CITY OF TAYLOR, TEXAS

PLANNING AND ZONING COMMISSION MEETING

February 8, 2022, 6:00 P.M.

Staff has completed its review of plans for the Spring Creek Phase 1 SIP that is to be located at CR 367, Taylor 76574. There are some corrections that need to be made prior to approval of the plans. Your plans will be placed on the February 8, 2022 Planning and Zoning Commission meeting agenda. Comments from this review follow.

PZ-2021-1359

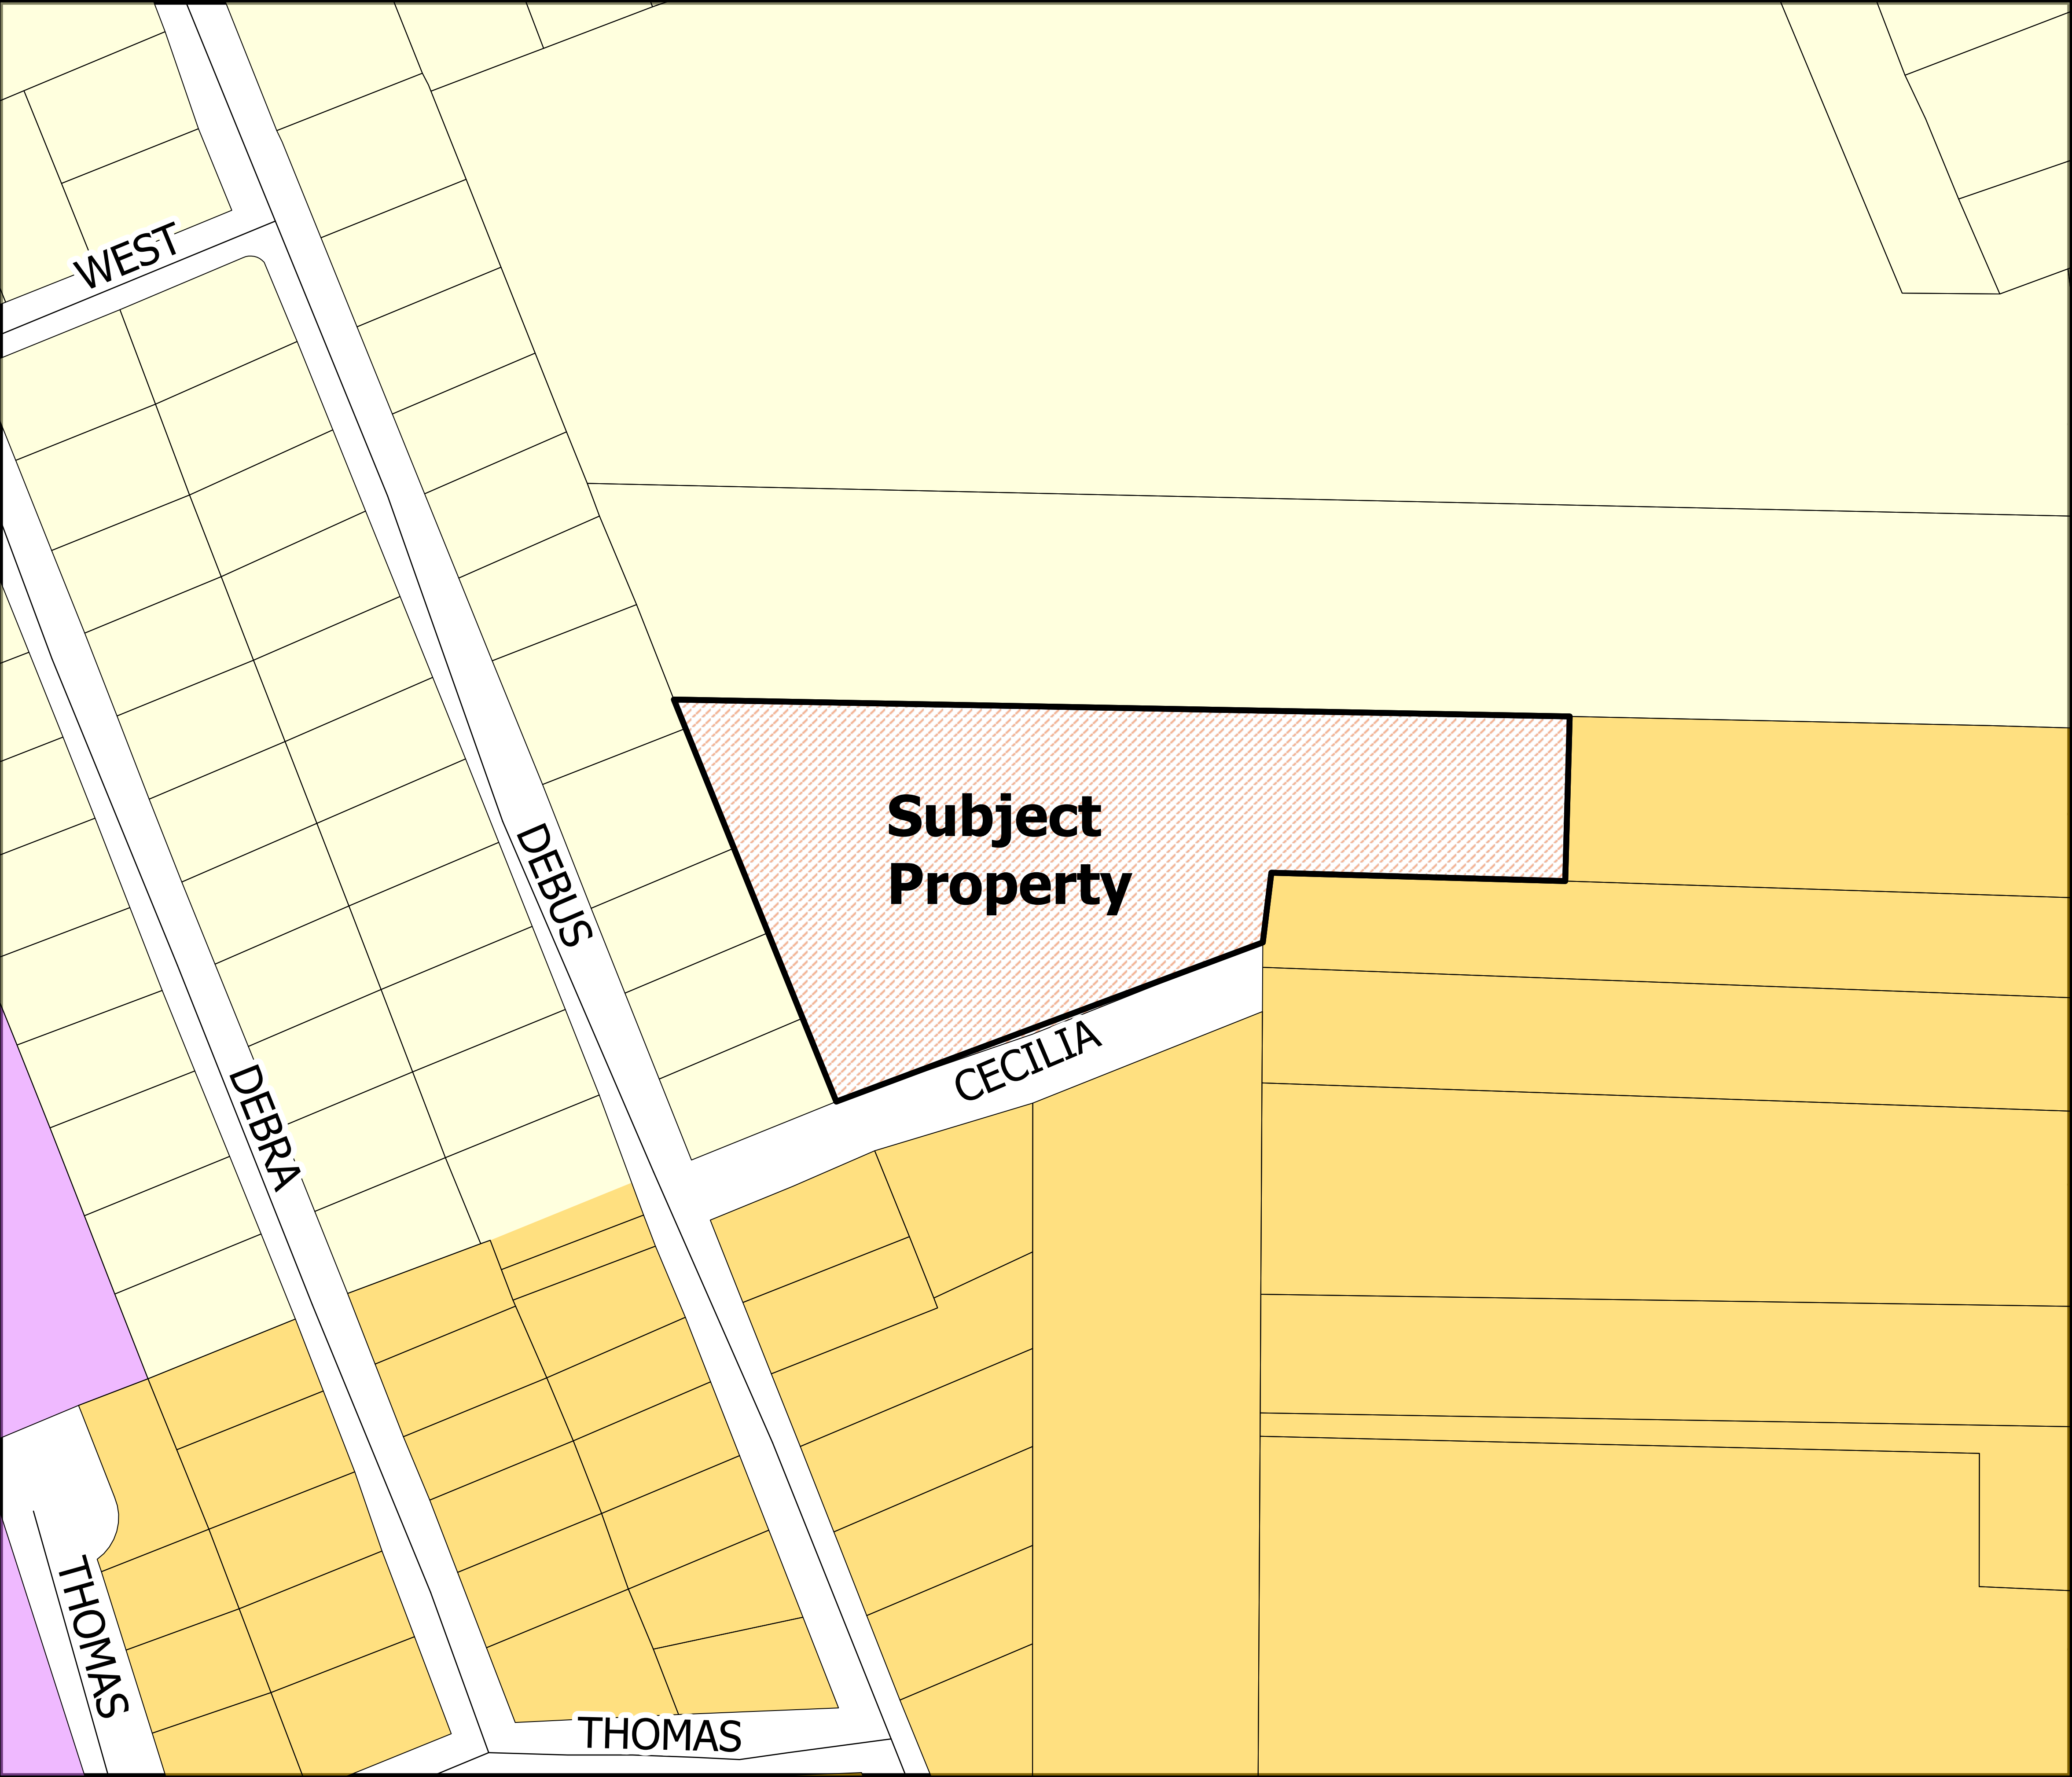
Updated January 15, 2022, the note below is still current. After the word "Georgetown" the state is "Text" instead of "Texas". The Clerk's certificate is still incorrect so copy and paste the correct certificate from the comment letter as stated previously and use it. Please use the exact wording required by the Williamson County Clerk's office. The Certificate on the plat is almost illegible on line 2 so just copy and paste. See below:

The Floodplain Note on Sheet 1 has Travis as the County instead Williamson.

- Engineer shall verify all required drainage easements prior to final plat submittal.
- It is noted that the final plat shall establish specific minimum floor slab elevations for construction of any structures on a lot within the one hundred (100) year floodplain to be a minimum of two (2) feet above the one hundred (100) year floodplain. (per Subdivision Ord. 3.3 Final Plat).
- Update the P&Z Certificate.

PZ-2022-1405

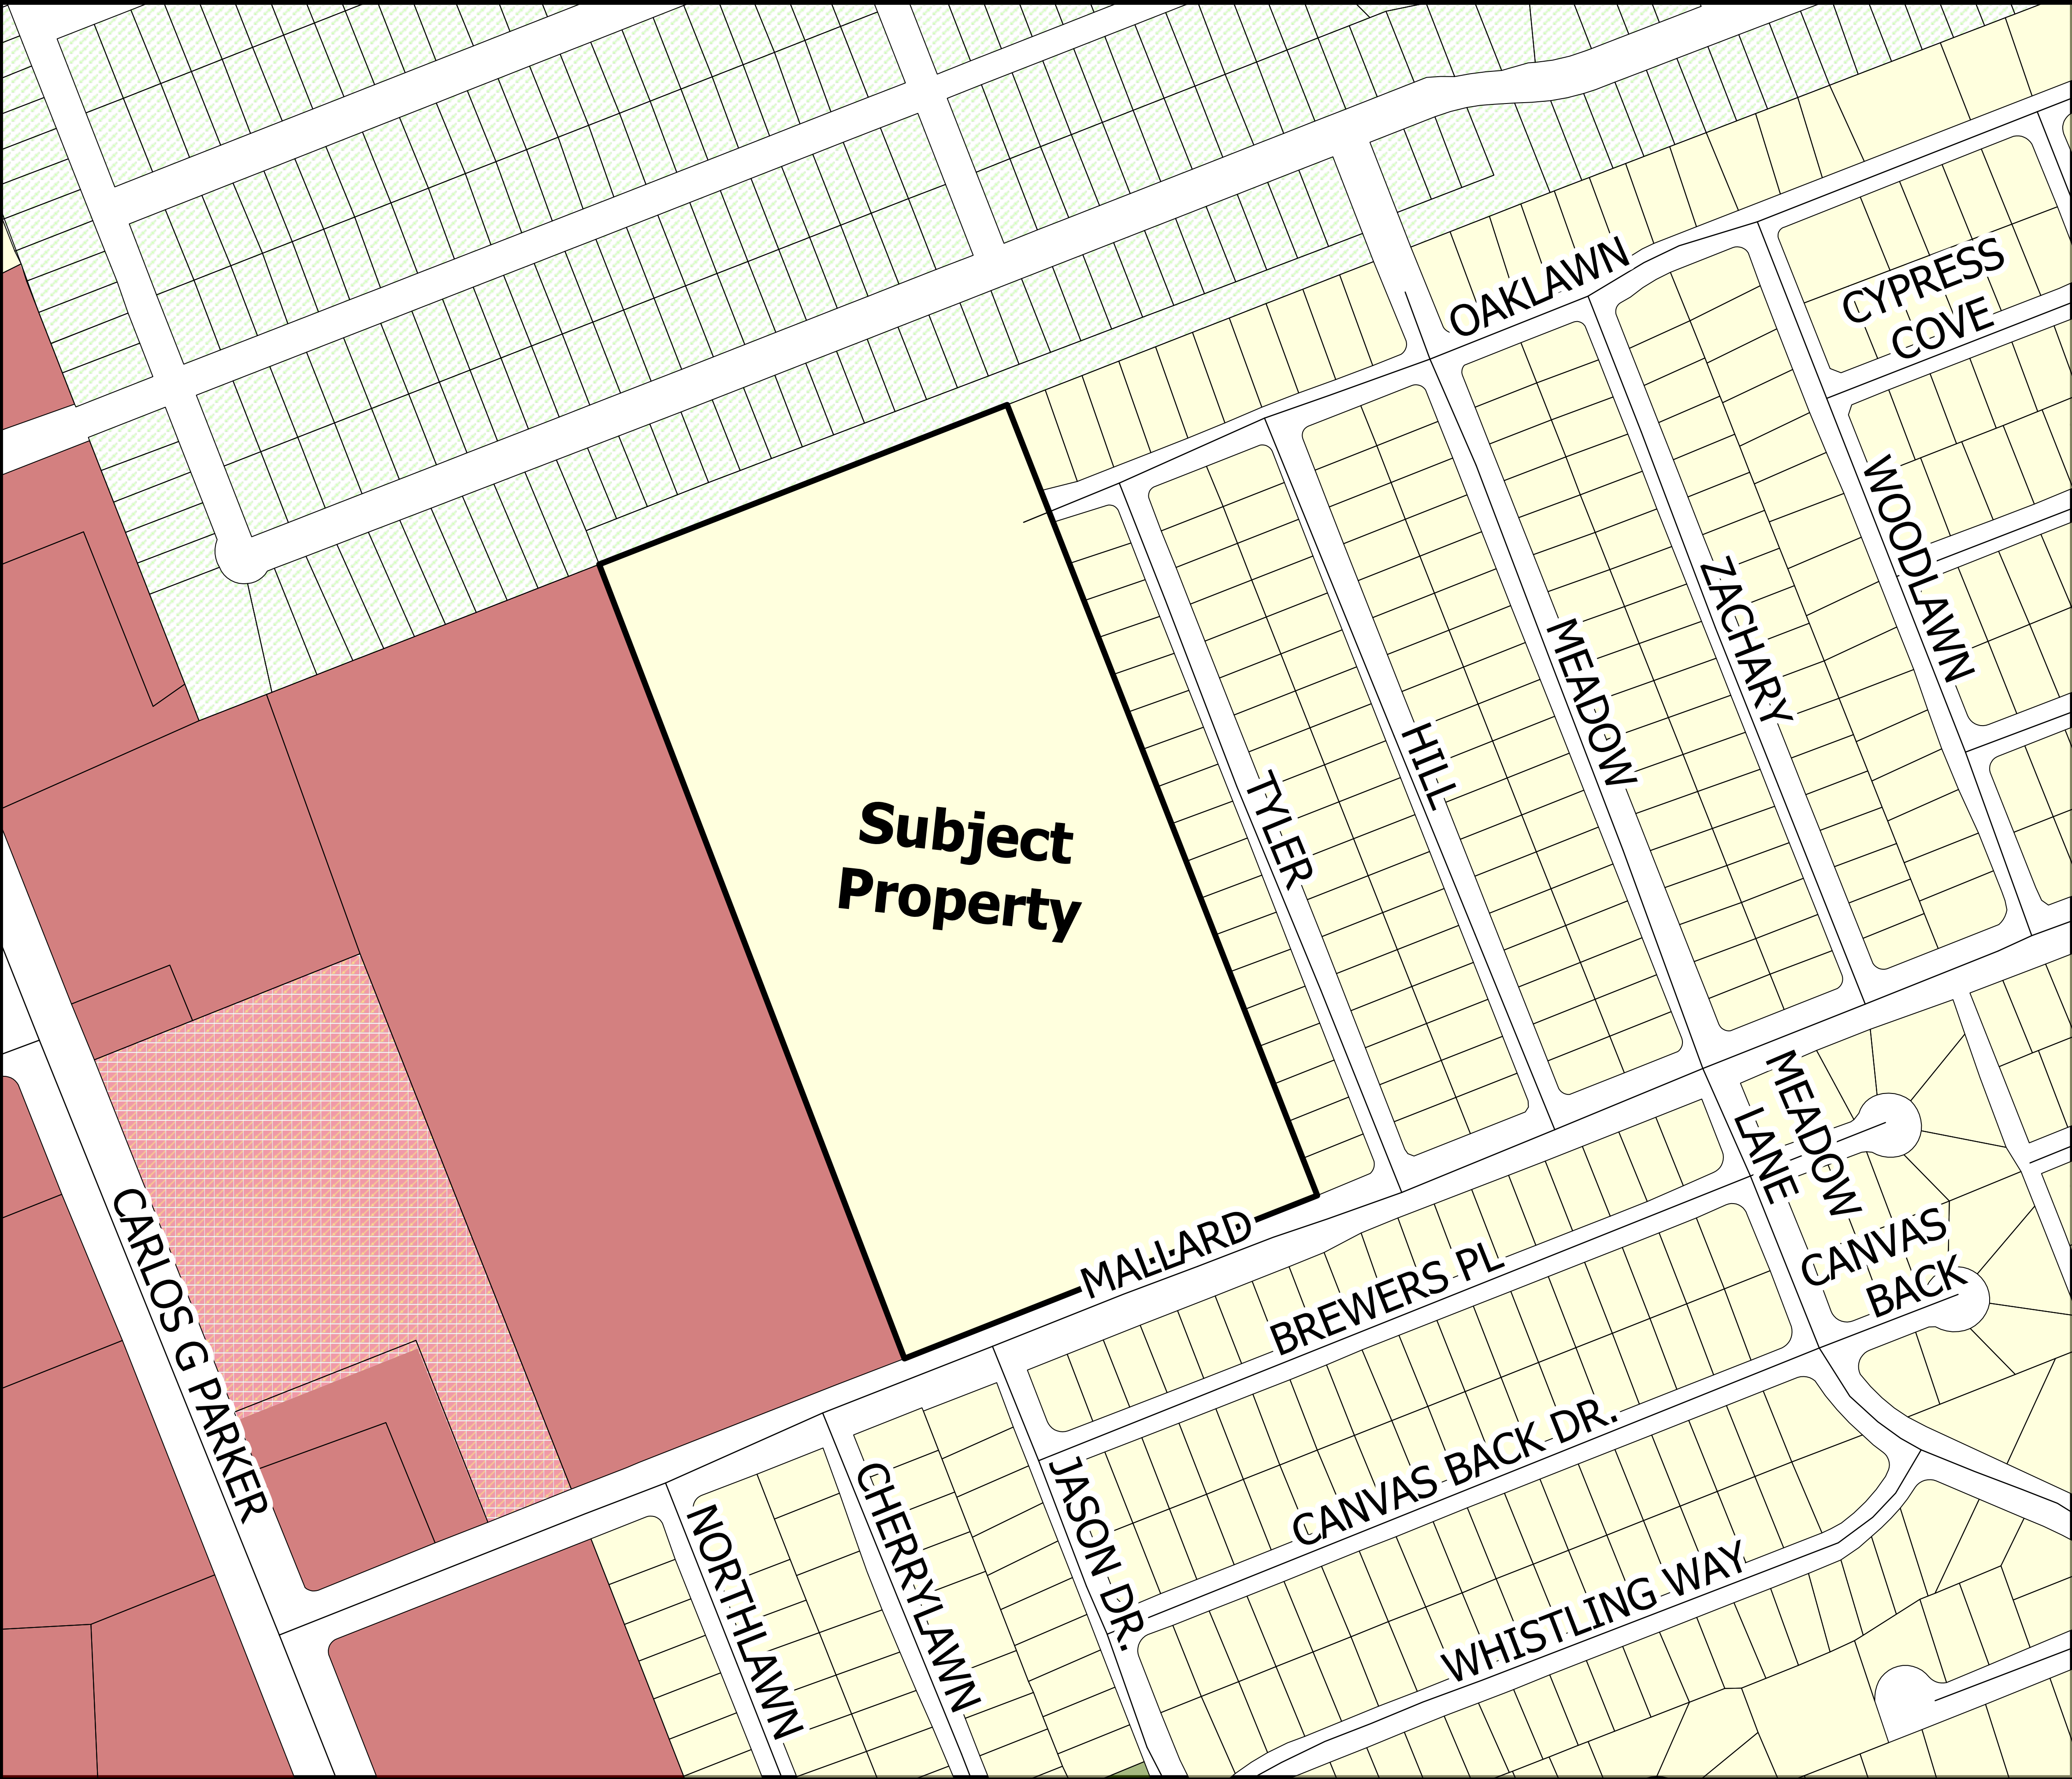
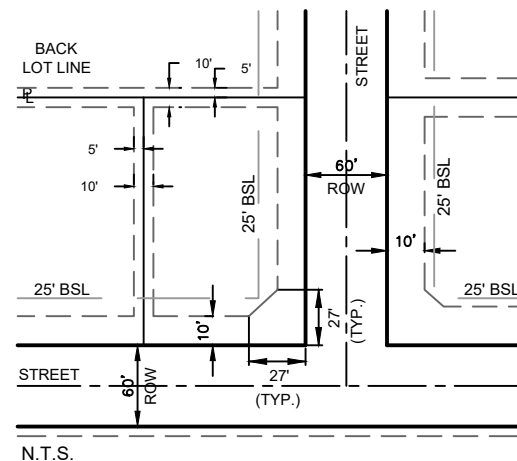
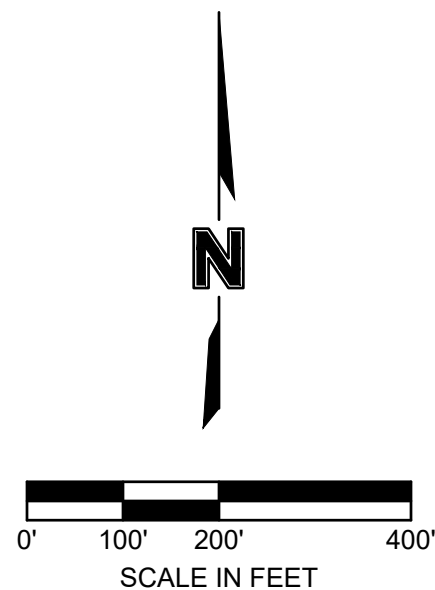
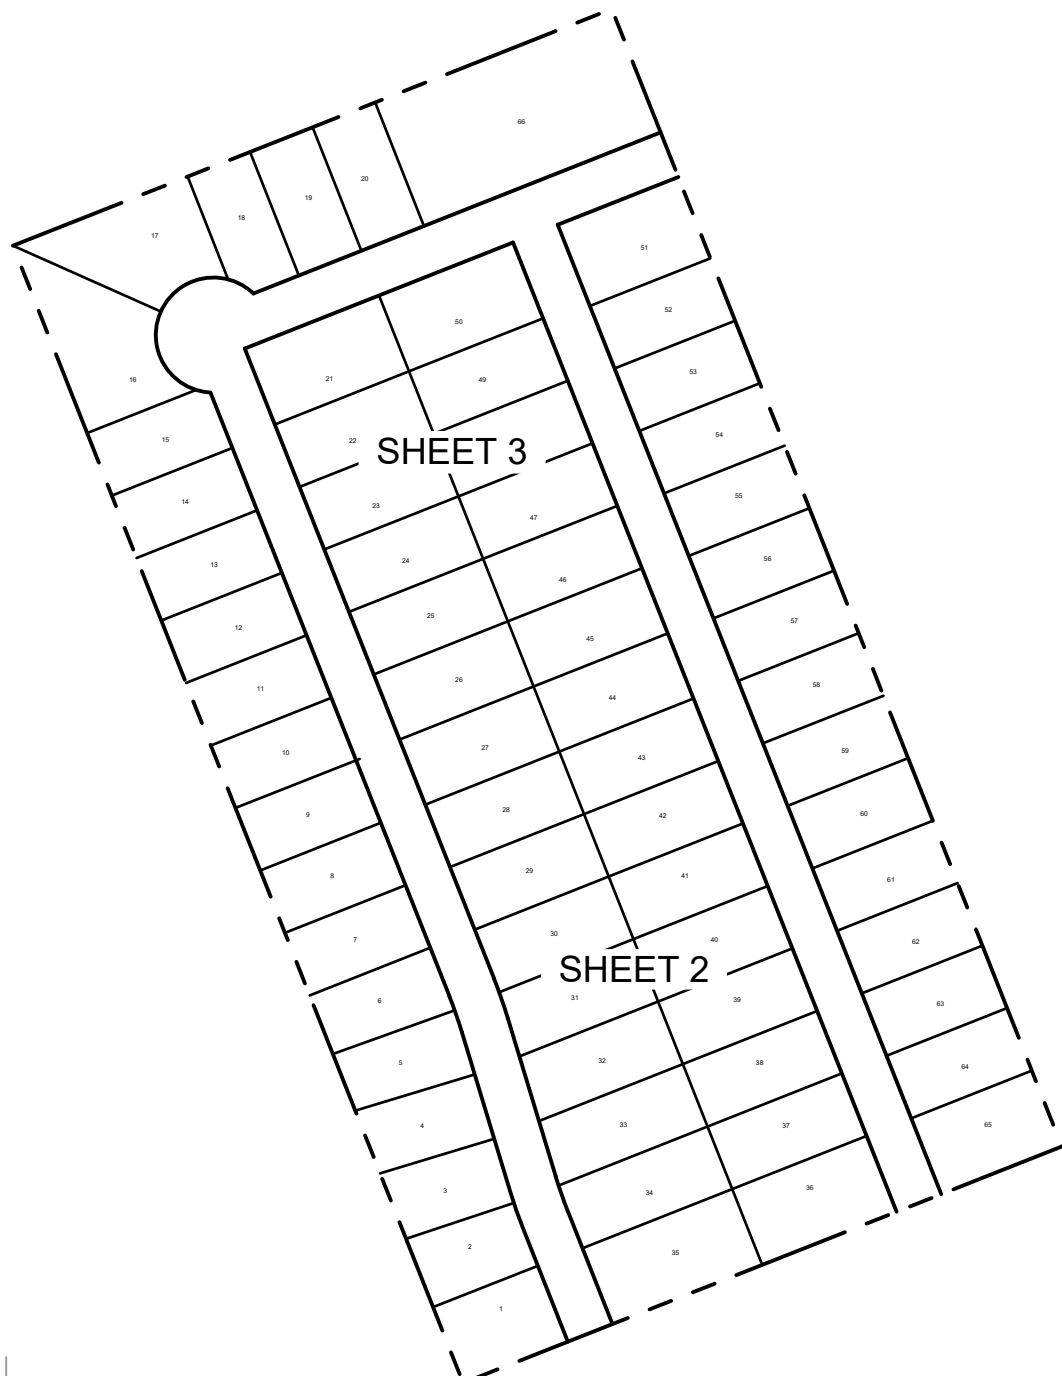
1. Street names do not meet with the County's approval. The street names have already been used.
2. Show sidewalks on the plat. Place a note about sidewalks and timing of construction in the General Notes. See Subdivision Excerpt below:

3. The Notes on Sheet 1 are not the notes that are required per the application. Additionally, General Notes for plats are usually on the last sheet. See required notes below:

4. MPRCWT is not one of the initialisms the County uses. If an initialism, acronym, etc. is not used on the plat map remove it from the Legend.
5. Remove the setbacks as a replat will be necessary if the Zoning Ordinance changes. The setbacks are according to the current Zoning Ordinance. The Zoning Ordinance is being updated currently.
6. The title and plat description must be along the top of each sheet in the middle. The title needs updating. The description is incorrect.

1. Verify if proposed subdivision can be shown on one sheet. If needed, rotate drawing to have Mallard drawn/shown as "sheet" east /west" instead of "true" east west. Subdivision Ordinance excerpt:

7. North arrow: North to be at top of sheet if possible.
8. Date: Each revision to bear new date.
2. For Plat Note #11, update note to say "City of Taylor Development Services". Include date of report on the reference.

5. Floodplain Administrator Certificate – Remove certificate if no floodplain exists within the subdivision (per Subdivision Application).
6. Owner Certificate – Update the total acreage shown; Include the "To Certify..." portion of the certificate; remove text "Excluding all drainage easements" and move to plat notes to denote the Drainage Easements to be maintained privately by an HOA/POA. Update the notary portion to match the language found in the "Owner's Signature Block" in the City of Taylor - Subdivision Application; Plat Submittal Requirements.

1. Move Curve Table to Sheet 1
